**COUNTY OF SAN MATEO
PLANNING AND BUILDING DEPARTMENT**

FROM: Planning Staff

SUBJECT: Consideration of a Design Review (DR) permit and Non-Conforming Use Permit (NCUP) pursuant to Sections 6565.3 and 6137.1, respectively, of the San Mateo County Zoning Regulations, to allow for a 434 sq. ft. first floor addition, a 758 sq. ft. second story addition, a new detached 655 sq. ft. 2-car garage with a half bathroom and outdoor shower, and remodel of an existing 701 sq. ft., 1-story, single-family residence, on a developed 5,729 sq. ft. parcel, associated with a NCUP. A NCUP is required to expand the non-conforming residence with a front setback of approximately 6 feet and 9.5 inches where 20 feet is required. The project involves only minor grading and no tree removal.

County File Number: PLN2024-00141 (Kostiuk/Bradley)

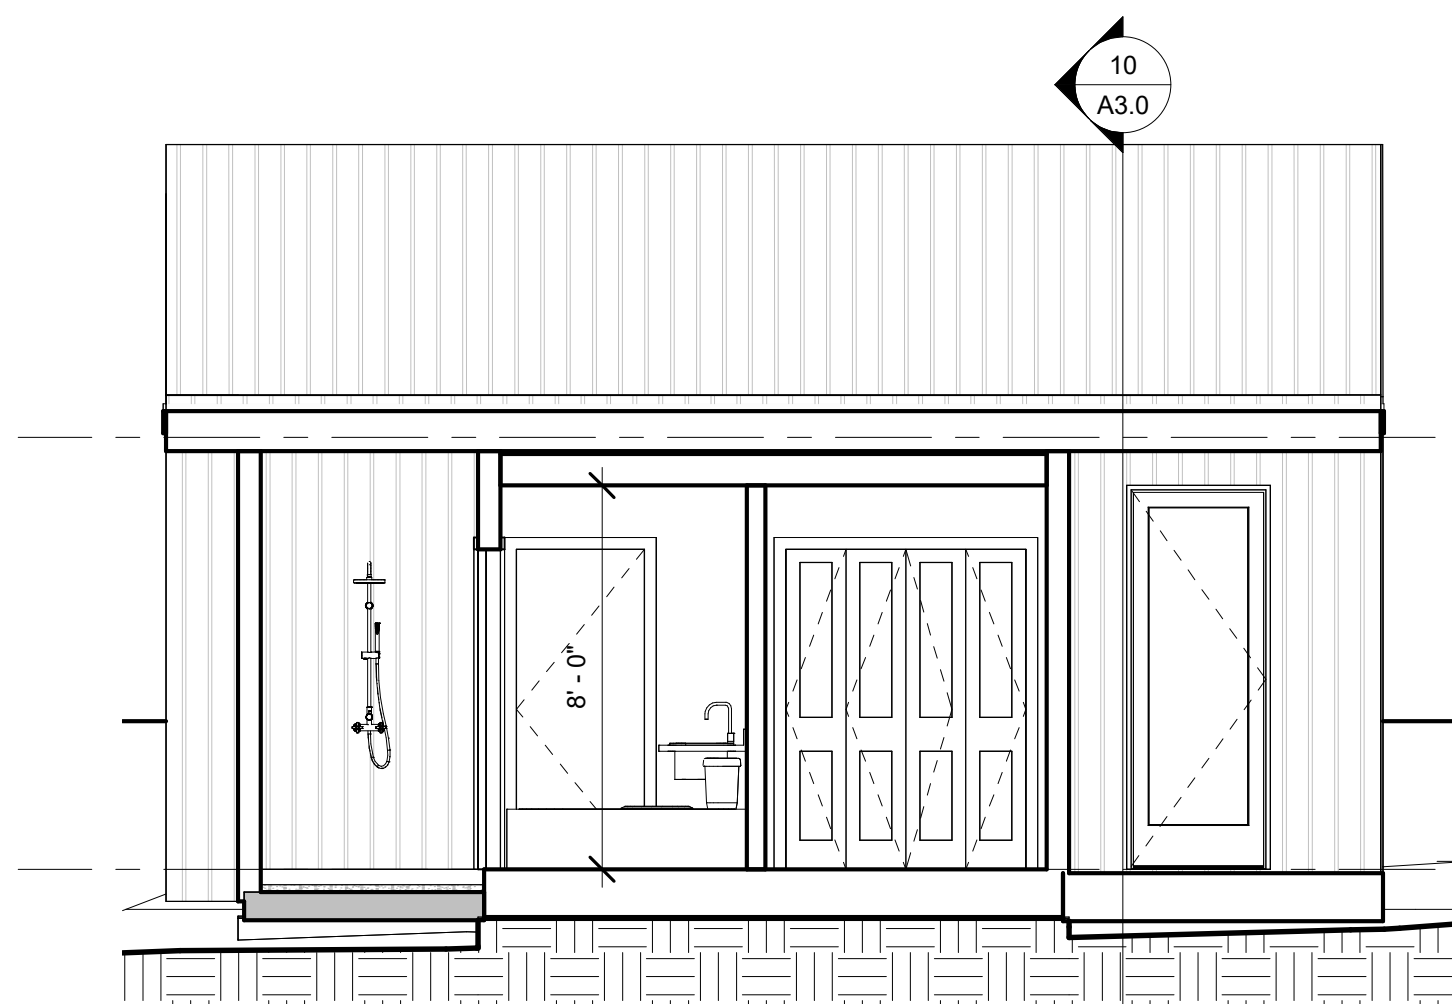
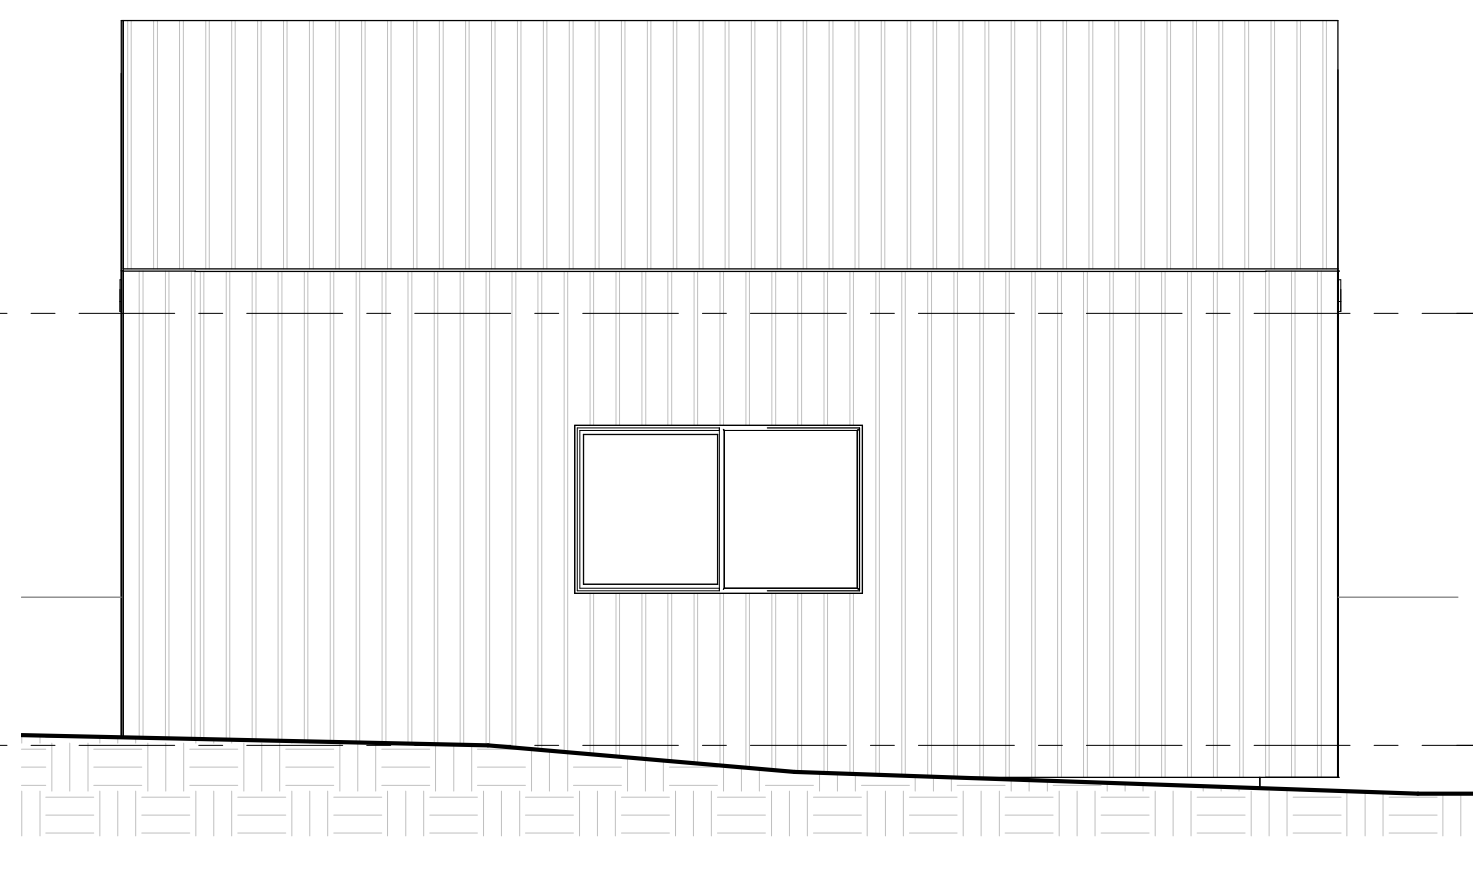
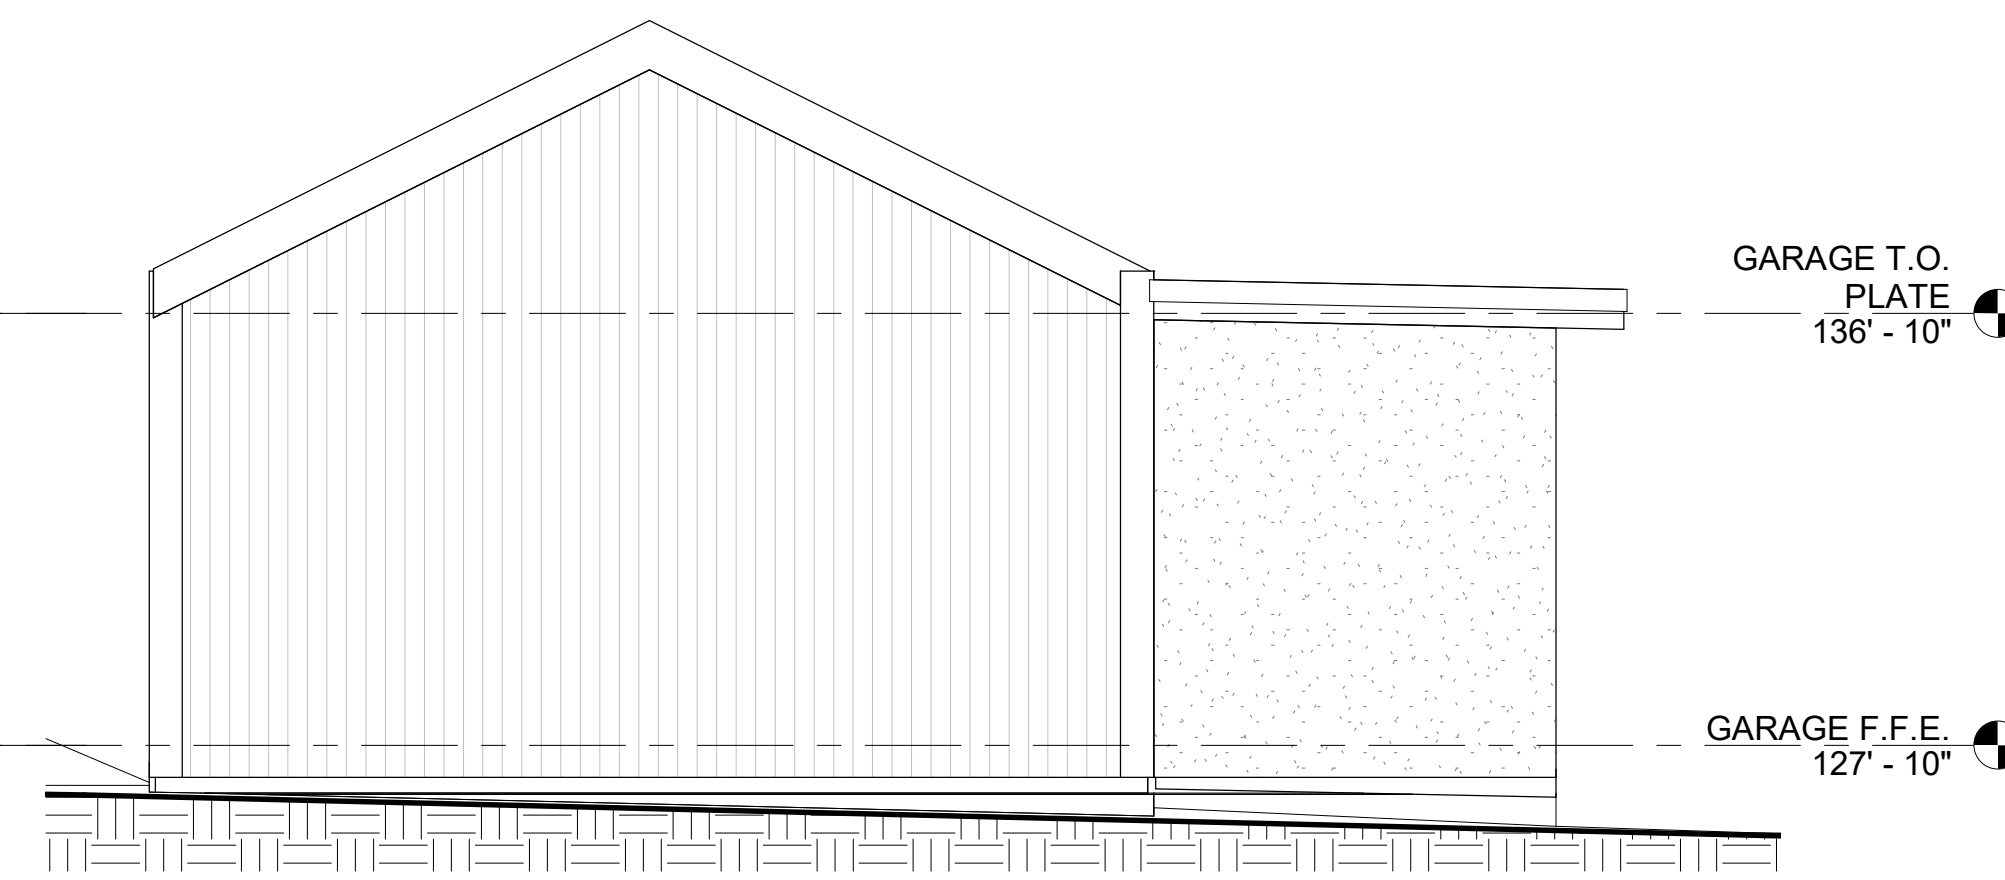
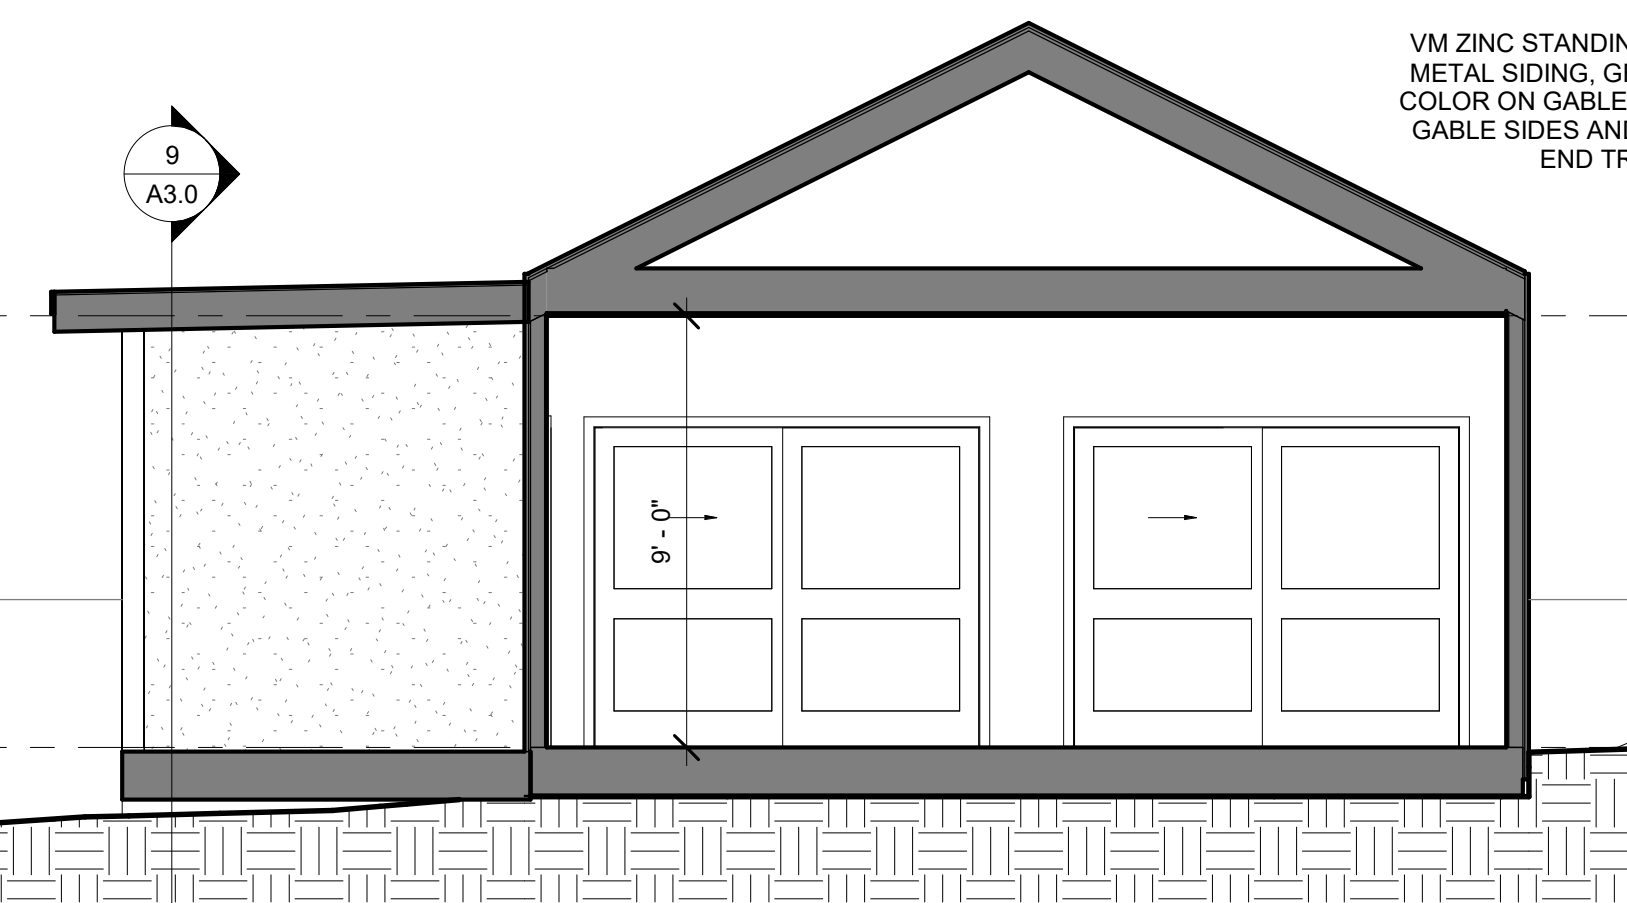
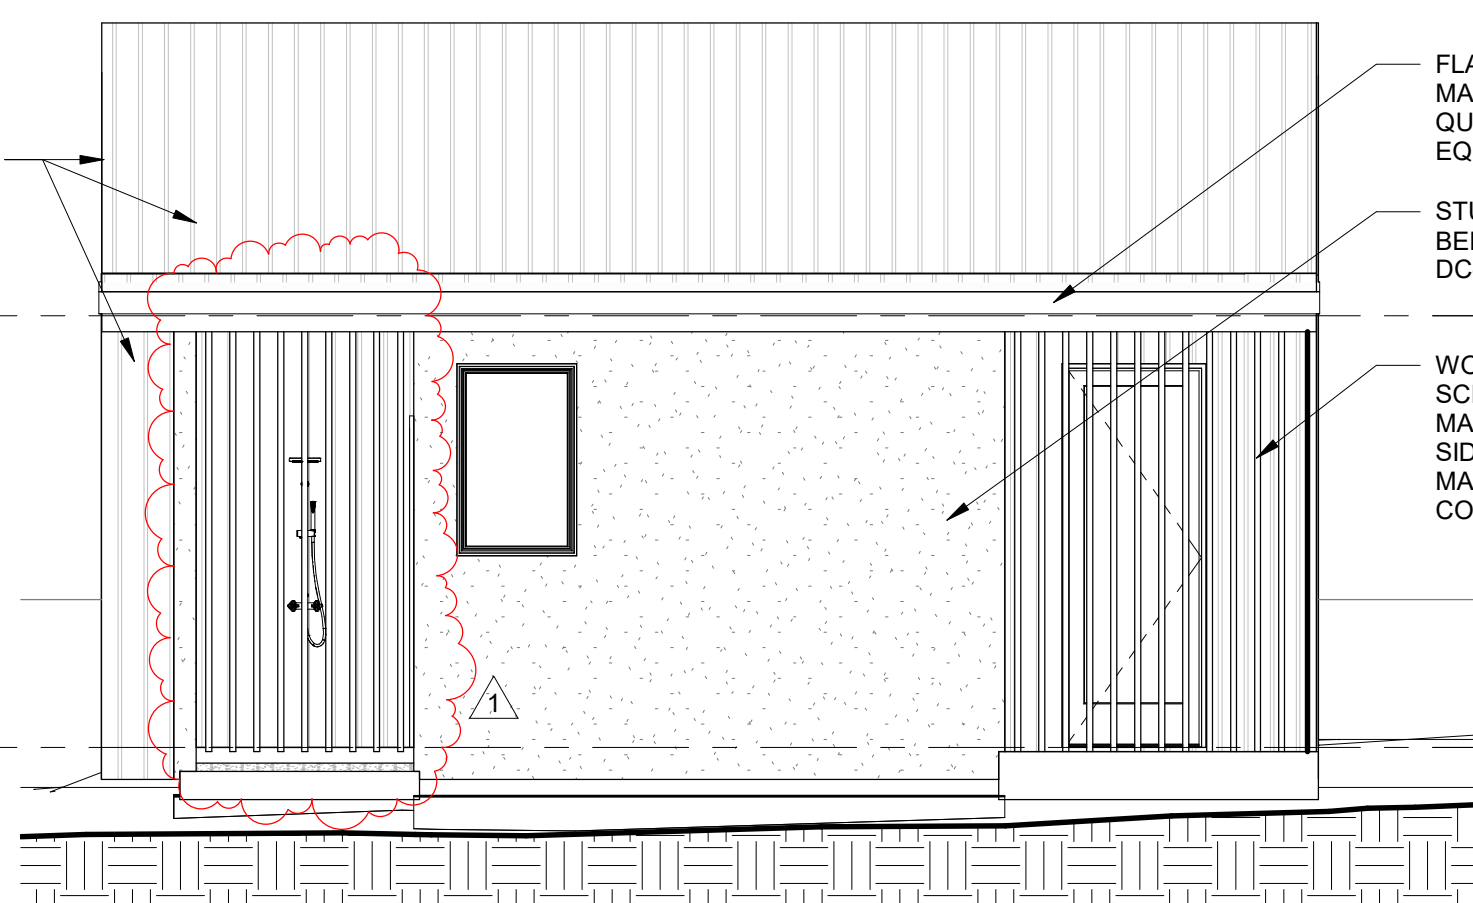
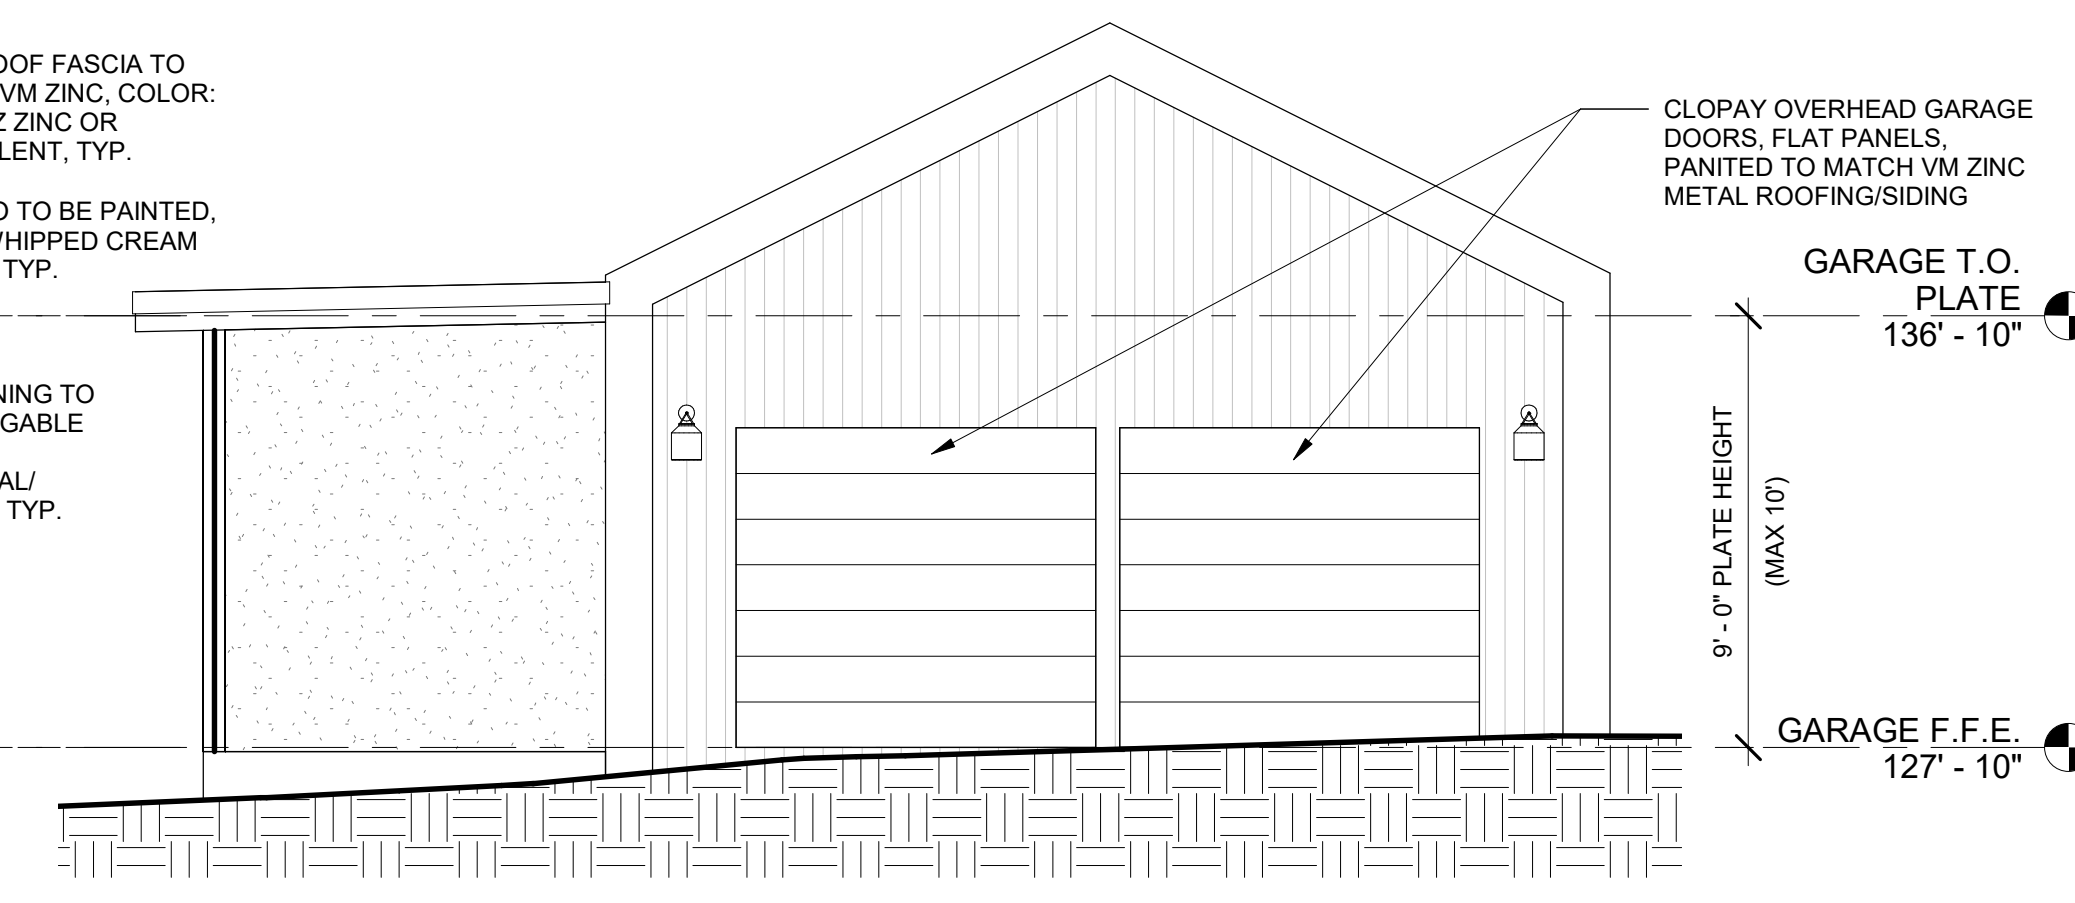
- (1) The maximum building height shall be reduced by a minimum of two feet.
- (2) The design shall change the horizontal siding adjacent to the front entrance (as shown on Sheet A3.2, BEHR FLIPPER PPU25-15) to a wood material to enhance design and prominence of the front entrance. The direction of wood siding can remain horizontal.
- (3) Recommendation: Use a darker color for the roof and roof fascia (proposed Quartz Zinc).

13. The maximum building height shall be reduced by a minimum of two feet.
14. The design shall change the horizontal siding adjacent to the front entrance (as shown on Sheet A3.2, BEHR FLIPPER PPU25-15) to a wood material to enhance design and prominence of the front entrance. The direction of wood siding can remain horizontal.
15. Recommendation (Optional): Use of a darker color for the roof and roof fascia (proposed Quartz Zinc).
